<b>APPLICATION FOR PERMIT TO DRILL</b>		5. MINERAL LEASE NO: ML-22973	6. SURFACE: State
1A. TYPE OF WORK: DRILL <input checked="" type="checkbox"/> REENTER <input type="checkbox"/> DEEPEN <input type="checkbox"/>		7. IF INDIAN, ALLOTTEE OR TRIBE NAME:

2. NAME OF OPERATOR: WESTPORT OIL & GAS COMPANY, L.P.		9. WELL NAME and NUMBER: NBU 1022-18P	
3. ADDRESS OF OPERATOR: 1368 S 1200 E CITY VERNAL STATE UT ZIP 84078		PHONE NUMBER: (435) 781-7060	10. FIELD AND POOL, OR WILDCAT: NATURAL BUTTES

4. LOCATION OF WELL (FOOTAGES) AT SURFACE: 169' FSL 249' FEL AT PROPOSED PRODUCING ZONE:		11. QTR/QTR, SECTION, TOWNSHIP, RANGE, MERIDIAN: SESE 18 10S 22E

**TOPOGRAPHIC MAP** 01 15 06  
 MONTH DAY YEAR  
 SCALE: 1" = 1000' DRAWN BY: C.P. REVISED: 03-07-06 **D TOPO**

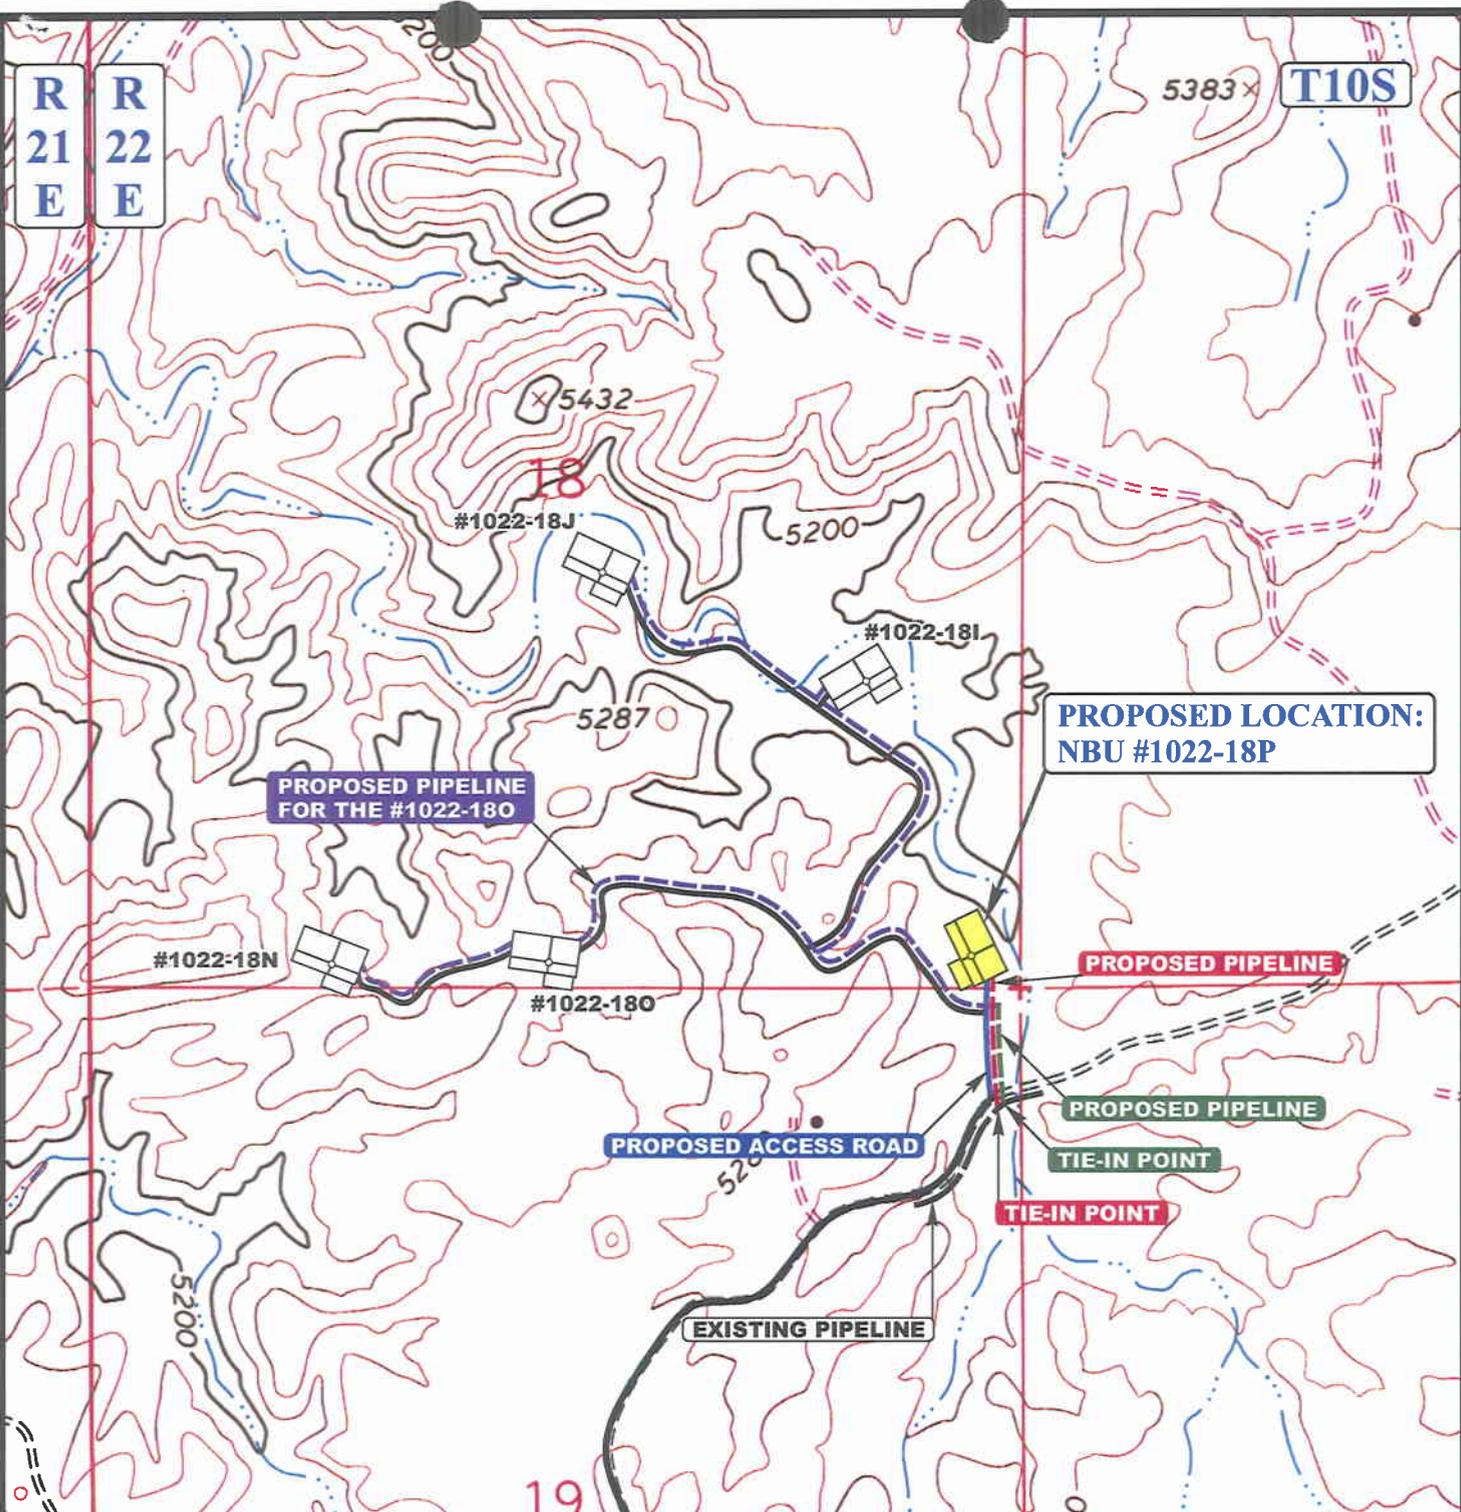
THE OPERATOR REQUESTS AUTHORIZATION TO CHANGE THE EXISTING PIPELINE PROPOSED IN THE ORIGINAL APD. AN ON-SITE WAS CONDUCTED ON 02/23/2006 WITH THE UTDGDM REPRESENTATIVE. WHILE CONDUCTING THE ON-SITE INSPECTION IT WAS DECIDED TO CHANGE THE PIPELINE TO A TOTAL OF APPROXIMATELY 1161'+/- . A A APPROXIMATELY 500' +/- OF 6" PIPELINE IS PROPOSED AND A APPROXIMATLEY 661' +/- OF 4" PIPELINE IS PROPOSED.

Scale: 1" = 1,000ft	NAD83 USP Central	<b>EXHIBIT A</b>
Drawn: TL	Date: 15 July 2010	
Revised:	Date:

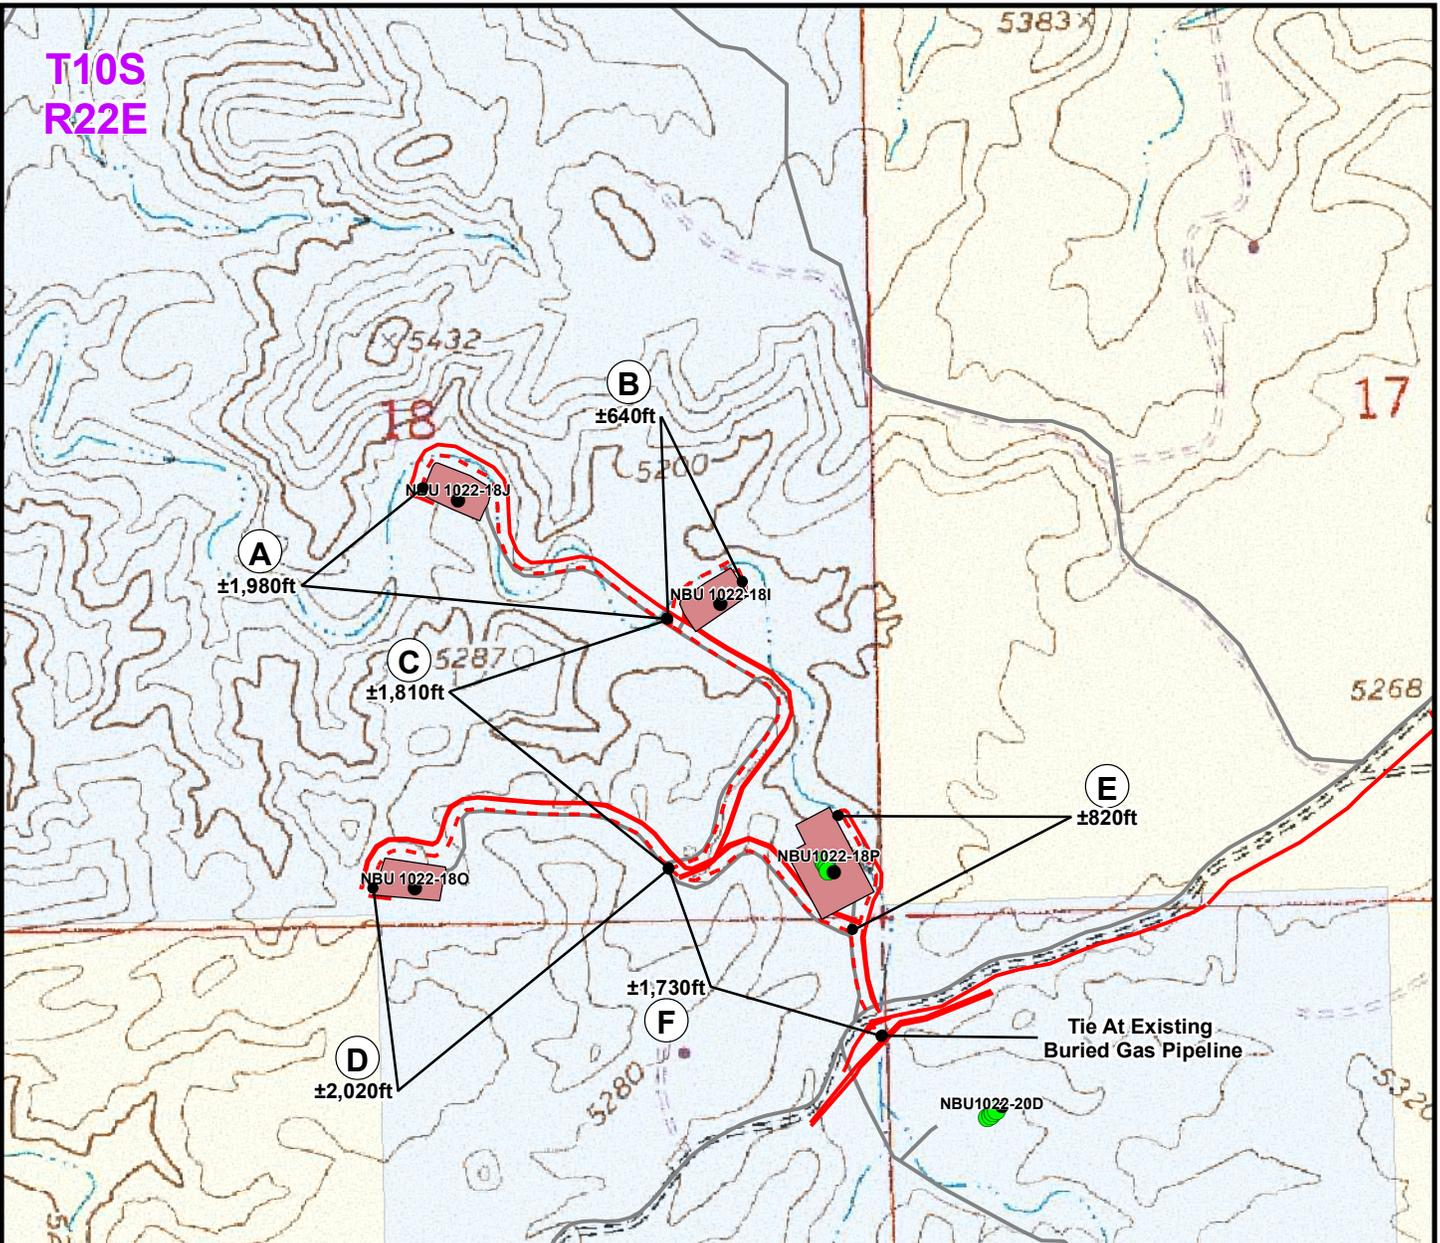
The operator requests authorization to implement artificial gas lift in the subject well. The associated pipeline right of way is being filed for and permitted under separate cover with SITLA. Please see attached gas lift measurement formula, downhole configuration proposal, and topo map of the project area.
